Basis of this breakdown

NORTHERN WOLVES AC

Snowflake Fitout - 7 Times Square, Floors 29-31 | COP-SF-05 Bulletin 3 Revision

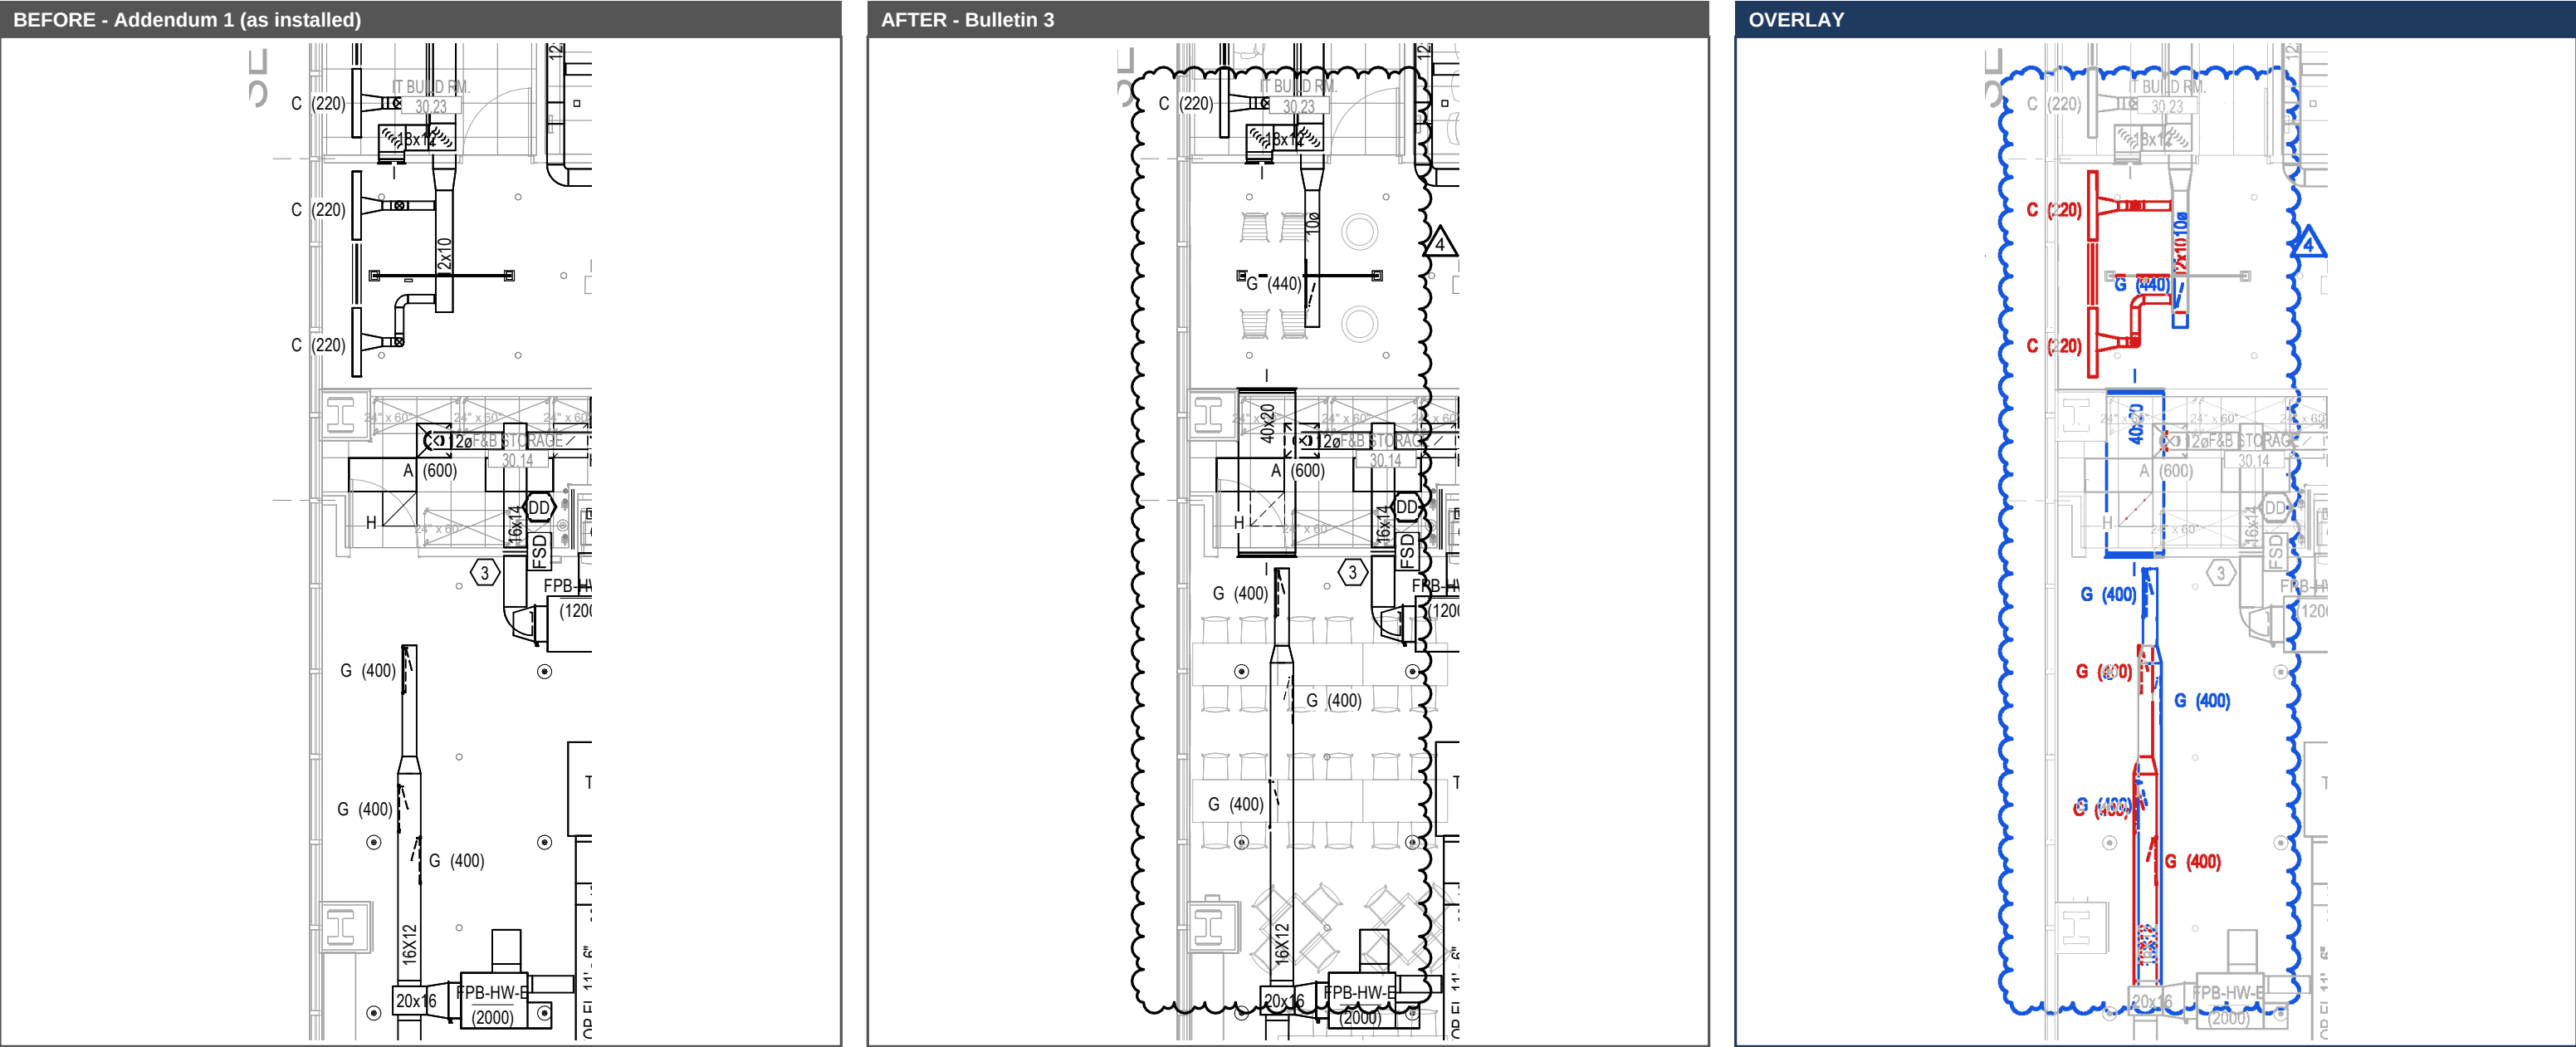
Before (Addendum 1, installed): 12x10 branch with (2) C(220) ceiling diffusers; G(400) linear diffuser run on 16x12 branch.

After (Bulletin 3): 12x10 branch and (2) C(220) deleted, replaced with 10ø branch to (1) new G(440) linear diffuser. New 40x20 transfer duct at F&B Storage 30.14. G(400) linear diffusers relocated along the 16x12 branch.

Work required: Disconnect and remove 12x10 branch and (2) C(220). Install 10ø branch, 40x20 transfer duct, rework 16x12 branch. F&I G(440) linear diffuser with plenum, relocate G(400) diffusers.

Area 30-2 - Lounge 30.02 - new transfer ducts

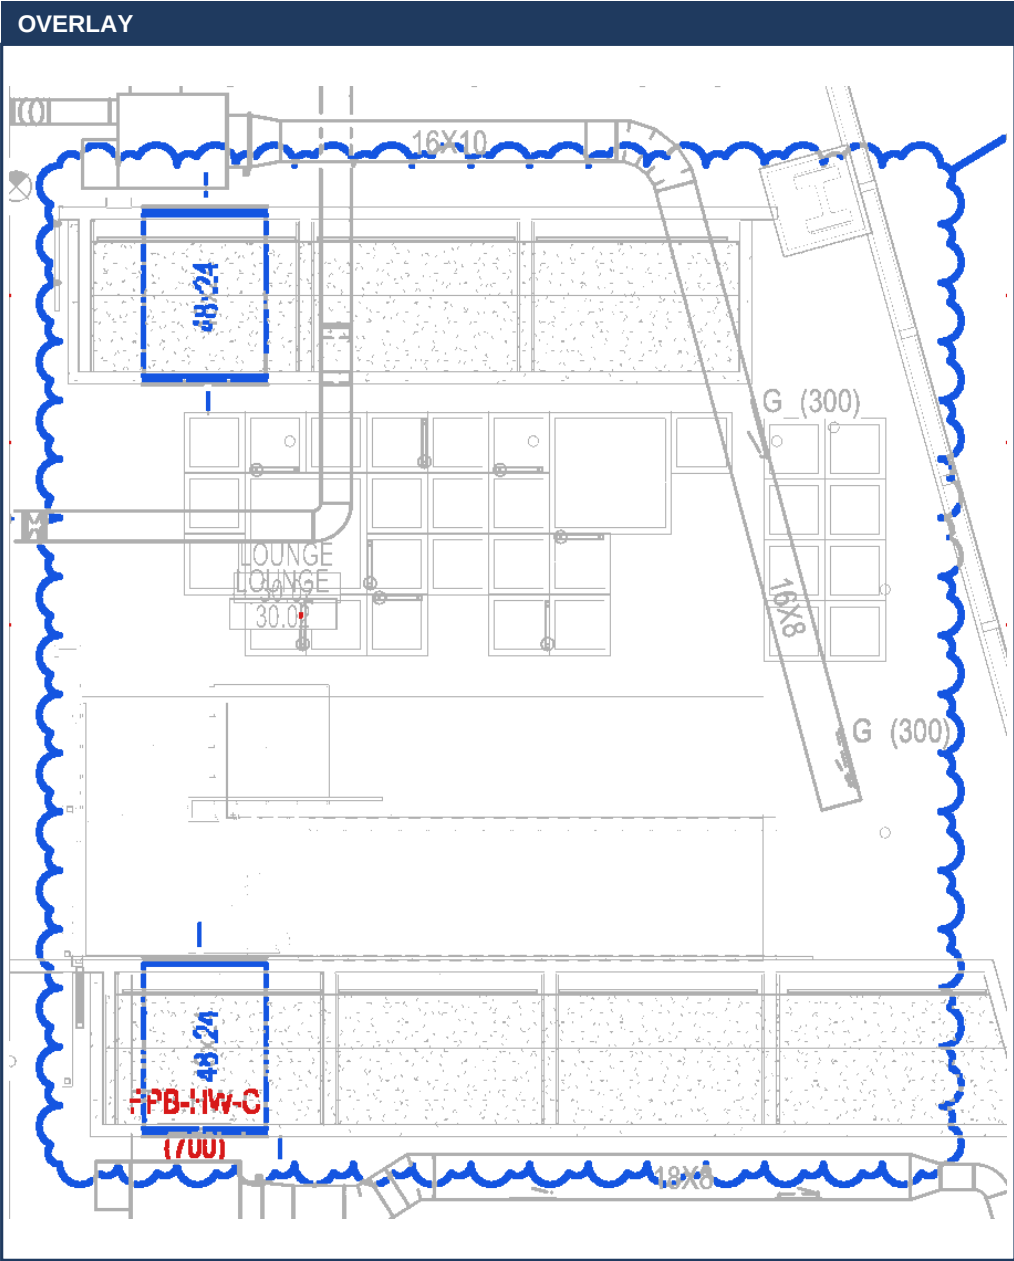
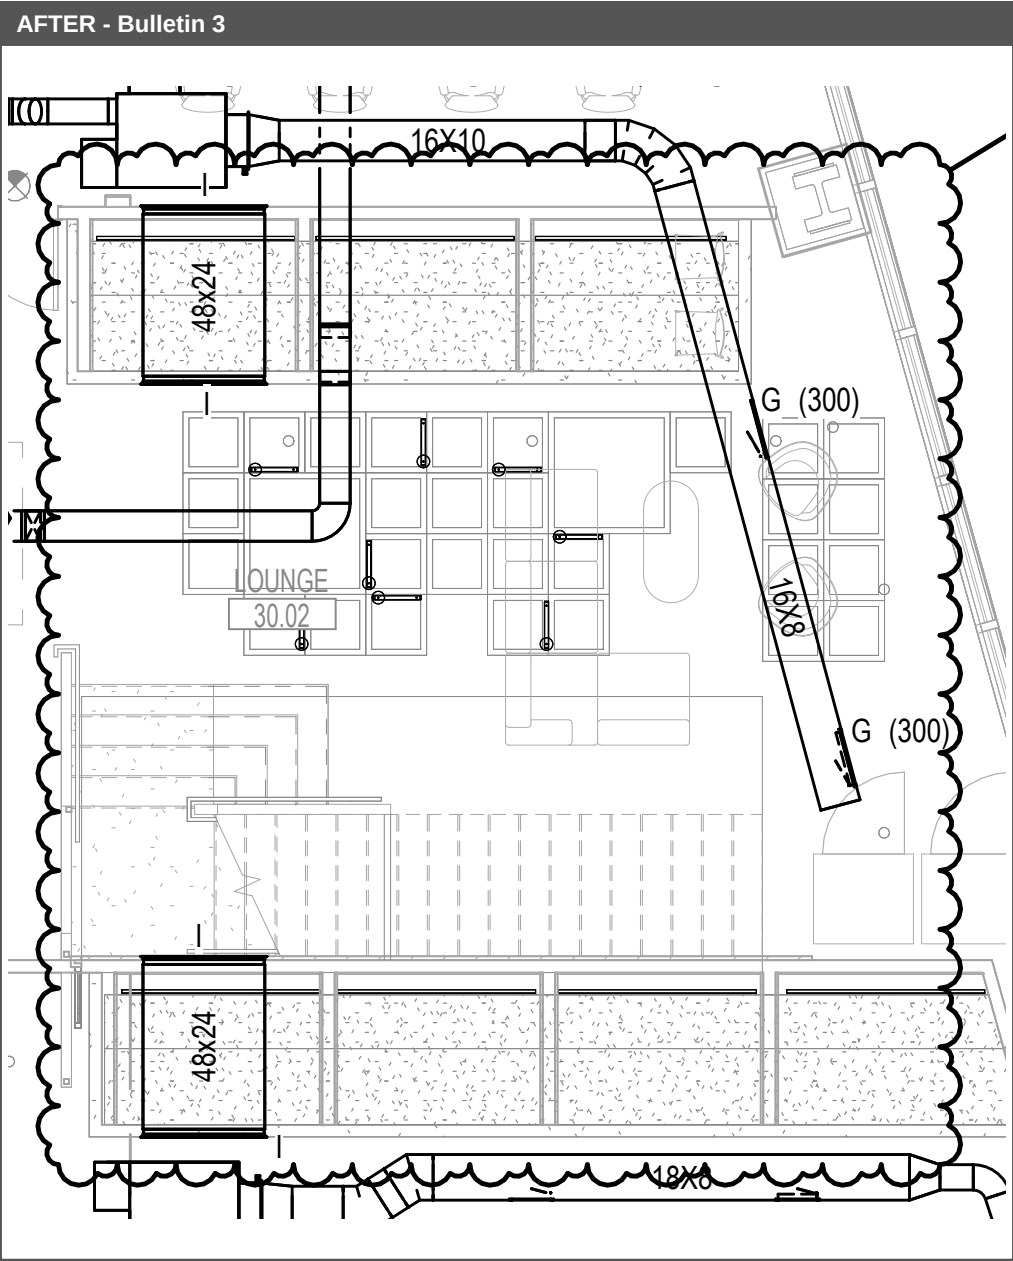
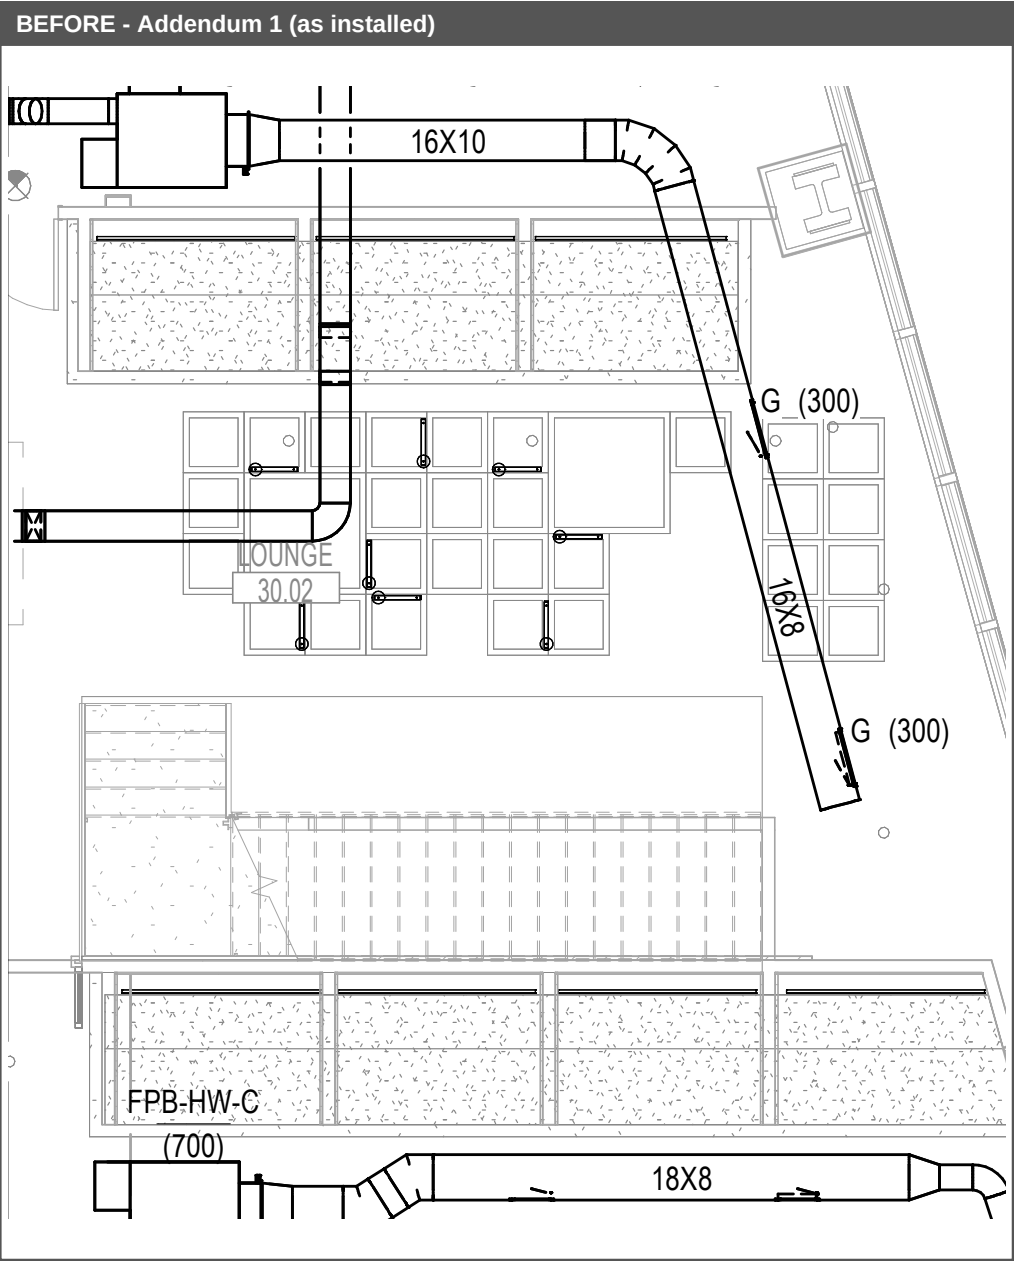
Before (Addendum 1, installed): No transfer ducts at Lounge 30.02 walls.

After (Bulletin 3): (2) new 48x24 transfer ducts.

Work required: Fabricate and install (2) 48x24 lined transfer ducts.

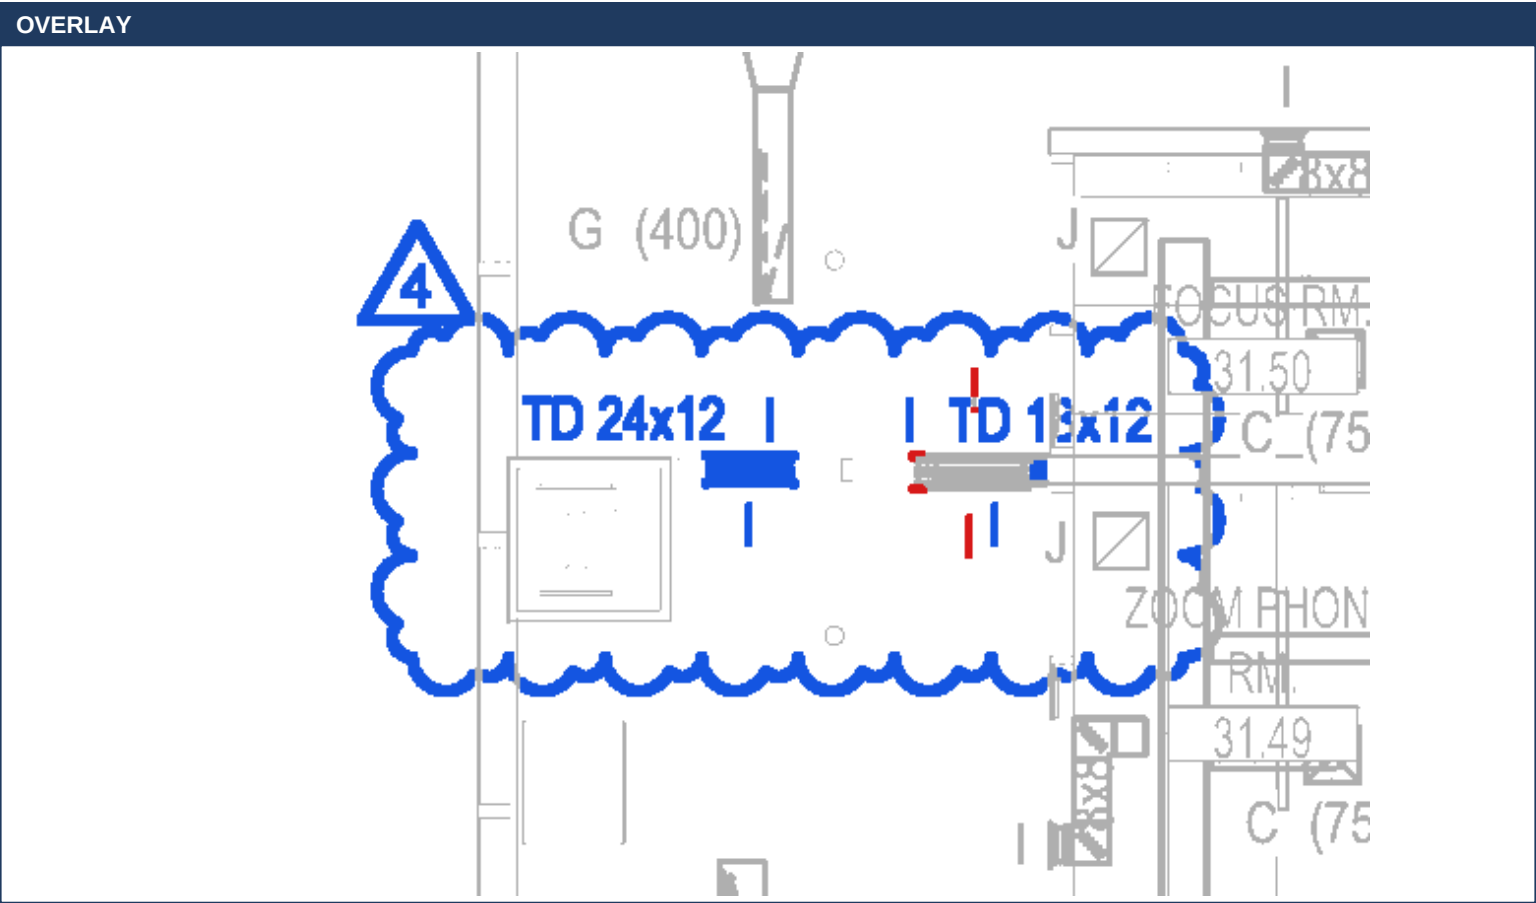
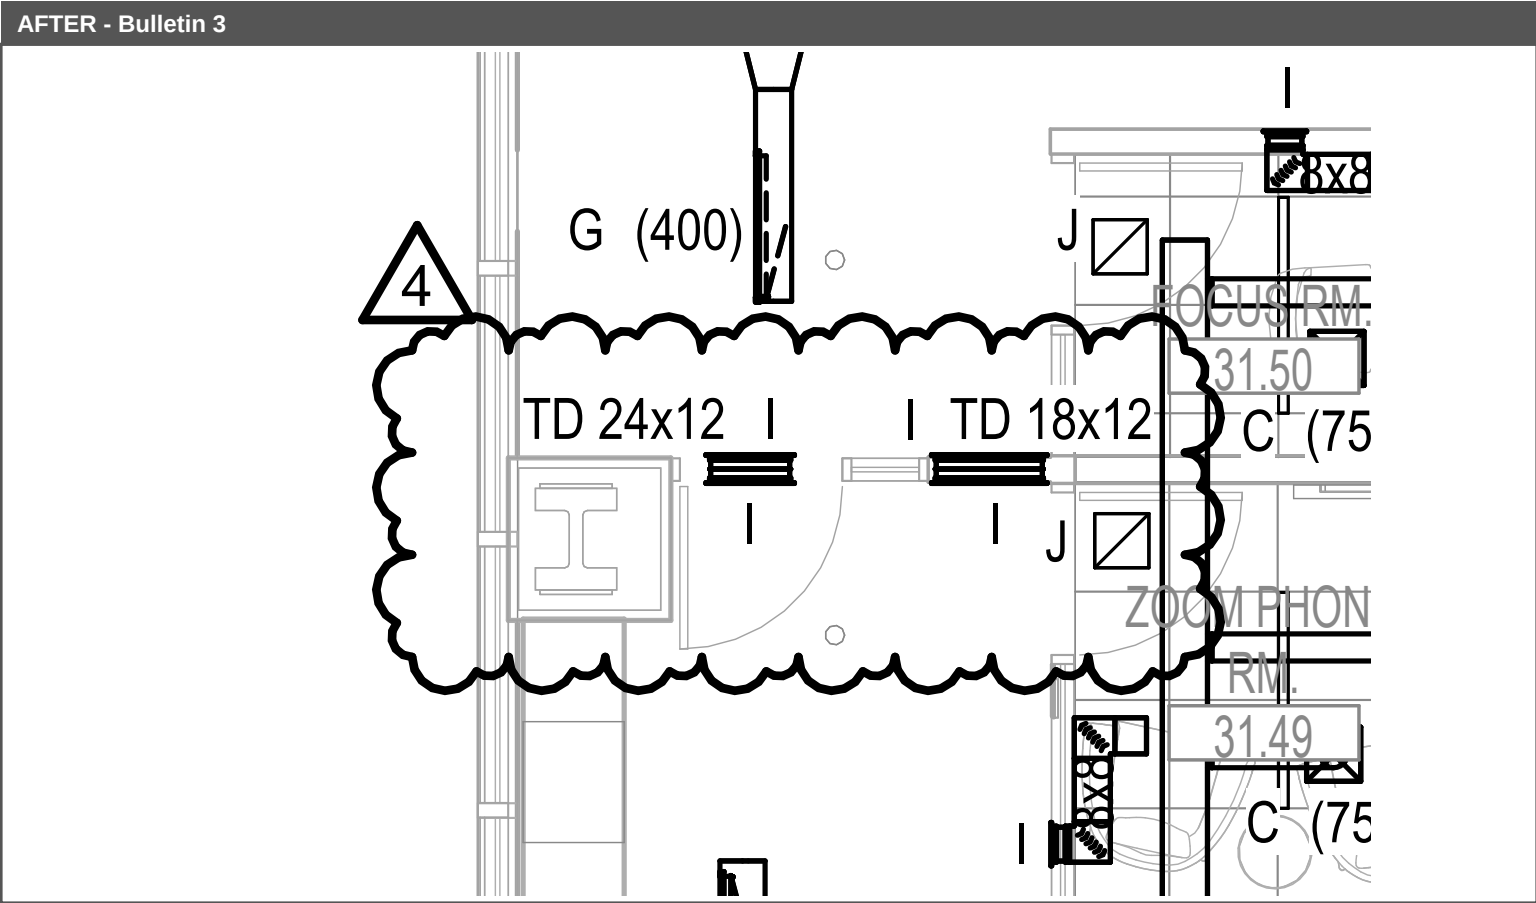
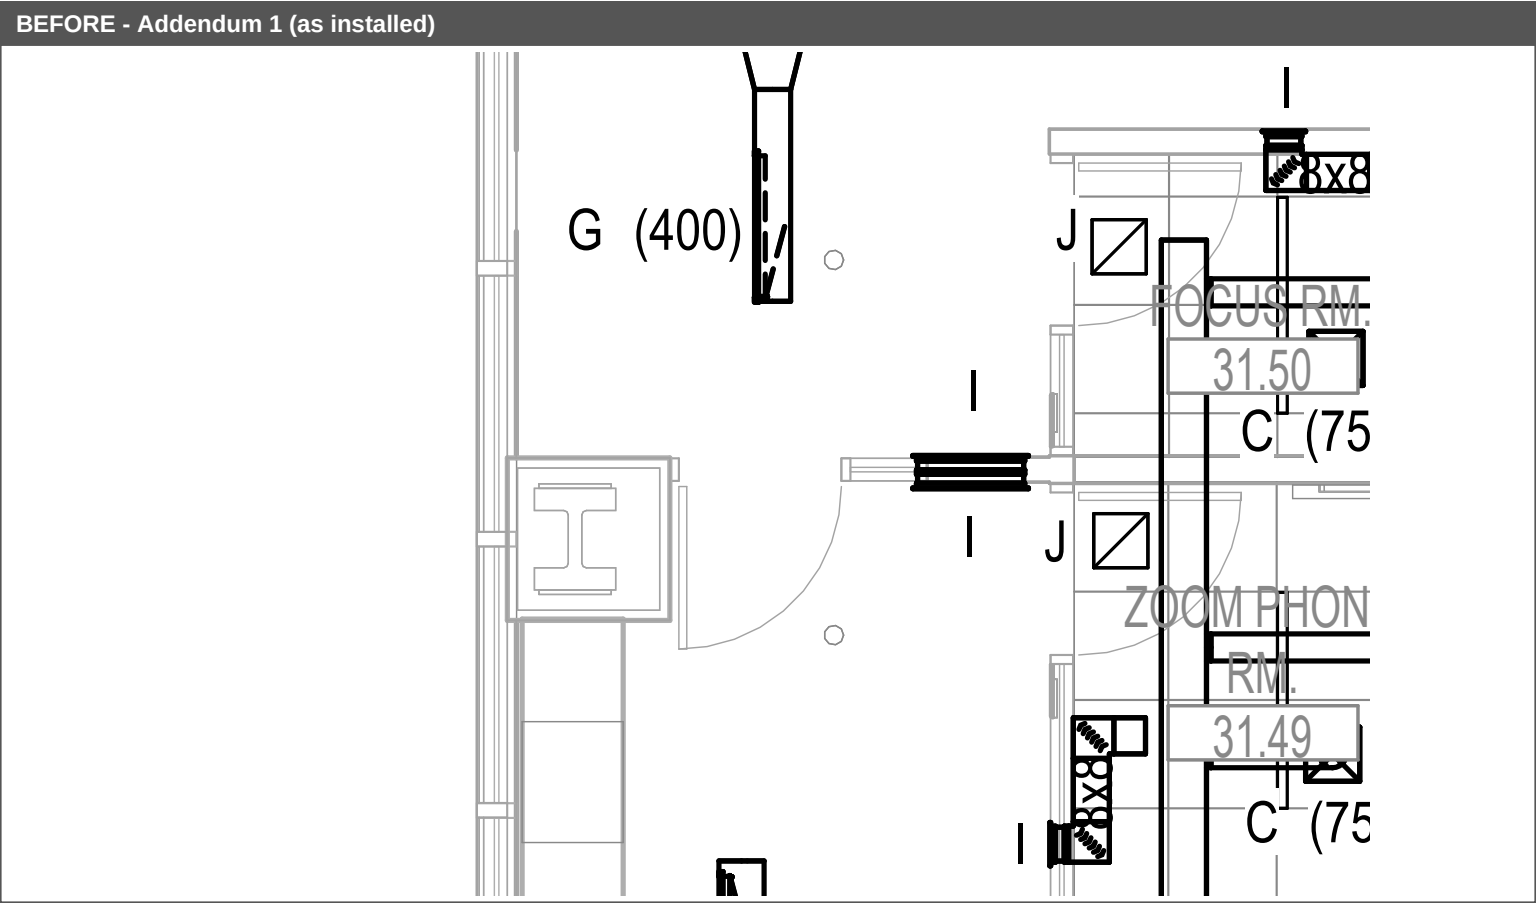
Before (Addendum 1, installed): (1) transfer duct (not sized on Addendum 1).

After (Bulletin 3): TD 24x12 and new TD 18x12.

Work required: Remove existing transfer duct; fabricate and install TD 24x12 and TD 18x12.
